Information Need No. AE-20**ER Figure 3.4-3, 3.4-11****Request:**

Figure 3.4-3 Circulating Water System Intake/Discharge Structure Location Plan

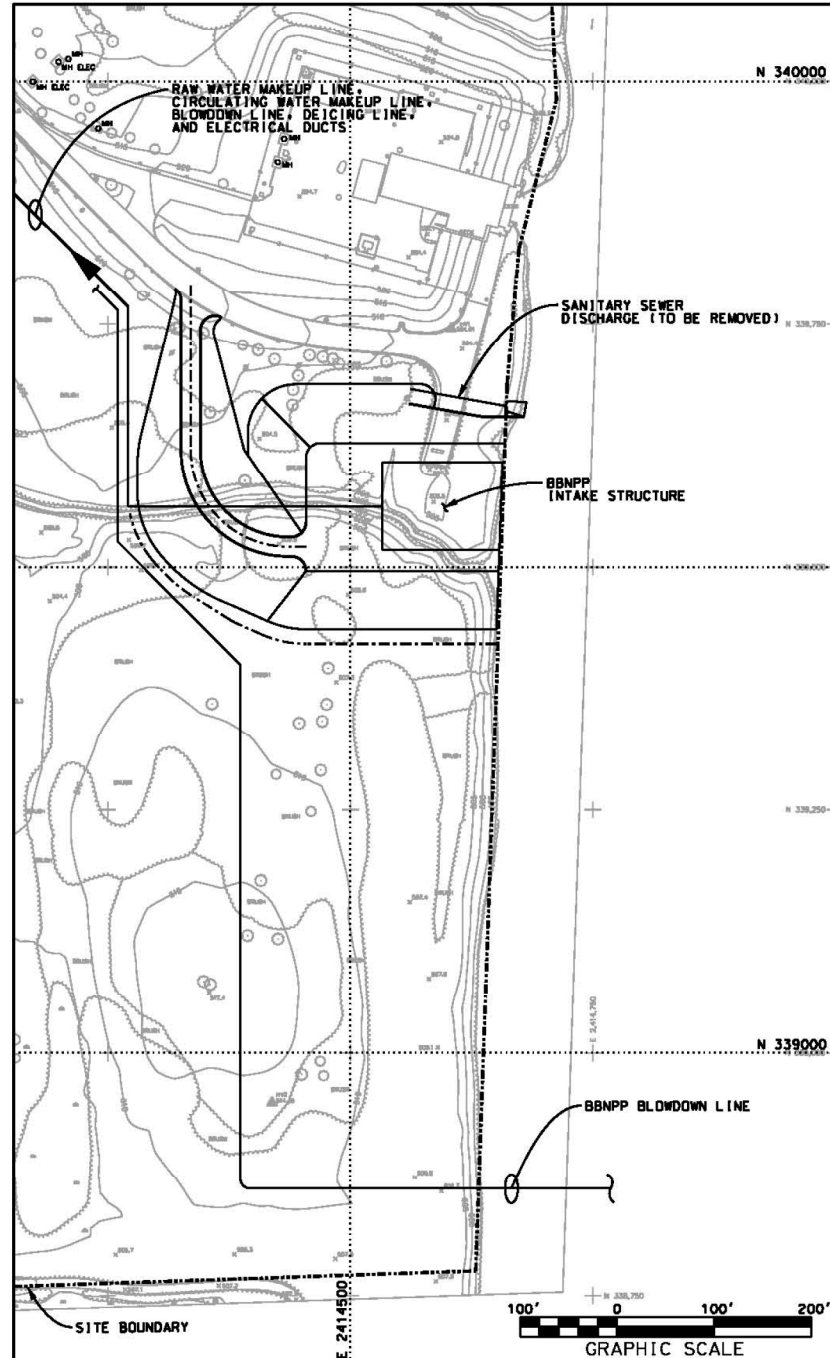
Provide a knowledgeable expert to discuss the existing sanitary sewer discharge upstream of the proposed location of the BBNPP intake system.

Figures 3.4-3 and 3.4-11 show a "Sanitary Sewage Discharge (to be removed)." This is presumably the line from the Current SSES Sewage Treatment Plant.

A knowledgeable expert will be available during the audit to discuss the existing sanitary sewer discharge upstream of the proposed location of the BBNPP intake system.

A large, new sanitary sewer line is being installed in the vicinity of the SSES plant along US Route 11. The new line is owned by the Berwick Area Joint Sewer Authority. The line will discharge into a treatment plant located in the Borough of Berwick. The sanitary sewer from the SSES plant presently discharges into the Susquehanna River. PPL is reviewing the option of connecting the SSES sanitary sewer line to this new line.

It is not planned for the sanitary sewer to continue to discharge into the river at the current location because of the possibility of the sanitary wastewater being drawn into the BBNPP intake.
